SITE PLAN & ARCHITECTURAL COMMISSION AGENDA DECEMBER 15, 2017

Project Buzz Thielemann Storage
Applicant: Buzz Thielemann; Agent: Scott Slack

File no. AC-17-110

To Site Plan and Architectural Commission *for 12/15/2017 hearing*

SITE PLAN
SCALE: 1" = 20'

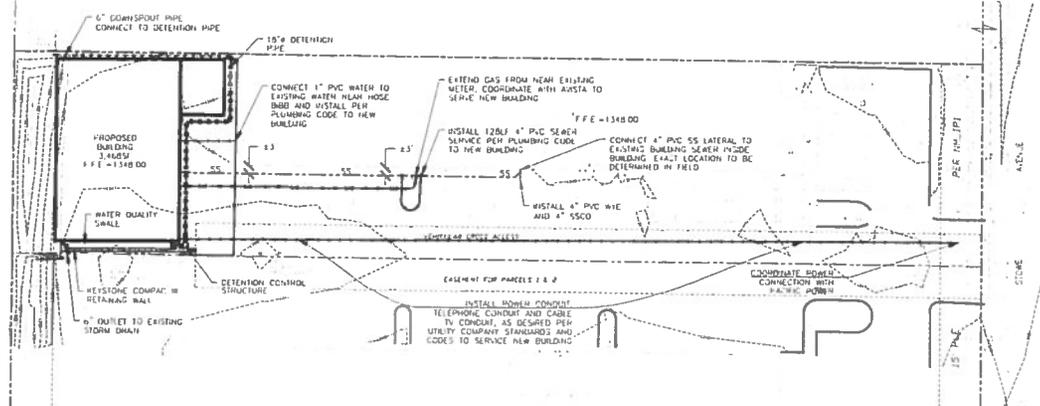
The proposed building height of 22.5 feet, as calculated per MLDC 10.705, requires a minimum side and rear yard setback of 1.25 feet. The applicant stated in the applicant's questionnaire that the setback to the north is at 1 foot. A condition of approval will be added for the applicant to submit a revised site plan showing the required setbacks per MLDC 10.721.

1. Submit a revised site plan showing side yard setbacks of at least 1¼ feet or reduce building height so that proposed 1-foot side yard setback is acceptable.
2. Comply with all conditions stipulated by the Public Works Department (Exhibit H)
3. Comply with all conditions stipulated by the Medford Water Commission (Exhibit I)
4. Comply with all conditions stipulated by Rogue Valley Sewer Services (Exhibit J)

STORM DRAIN PLAN & DETAILS

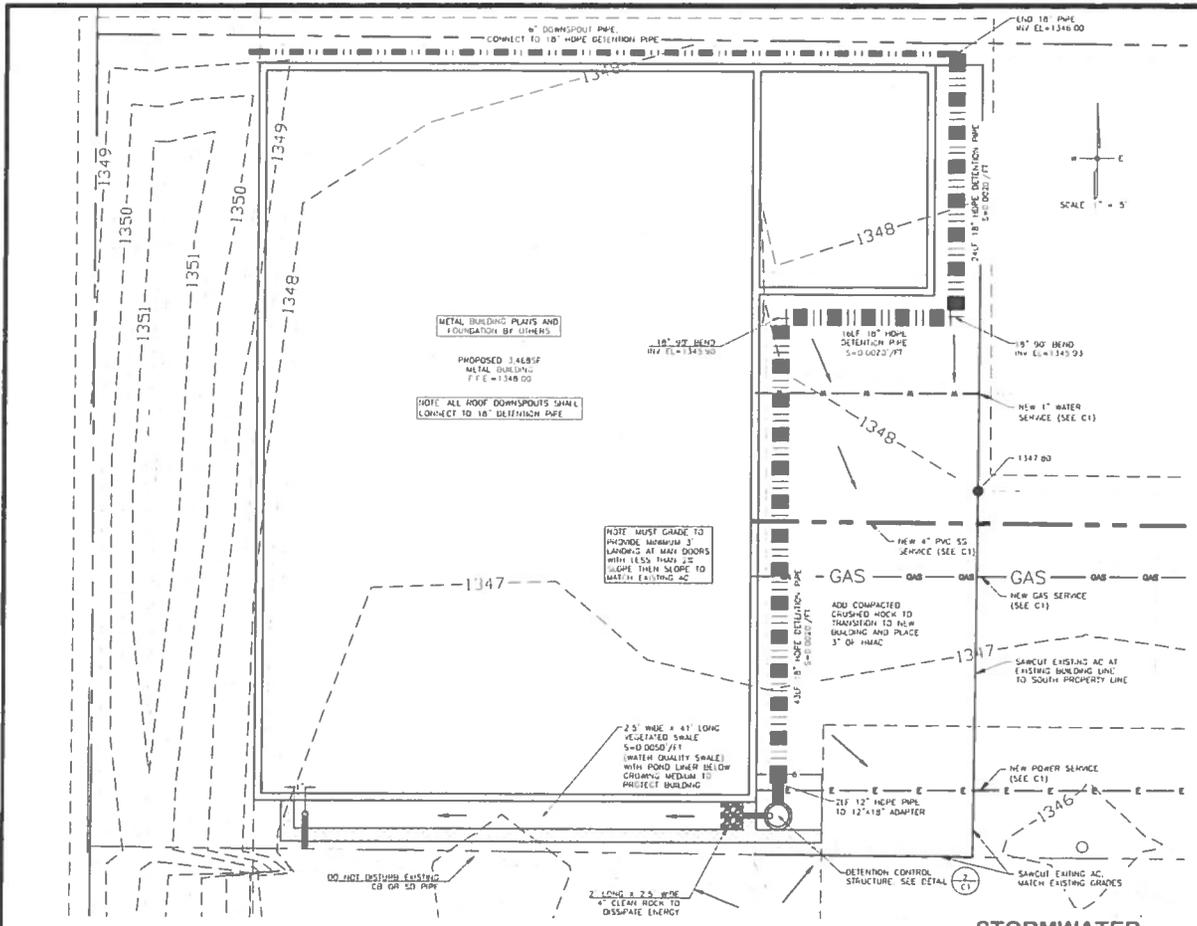
1. Drainage Plan

A Site/Utility Plan shall be submitted with the building permit application to show the location of existing or proposed stormdrain lateral/s for the site.
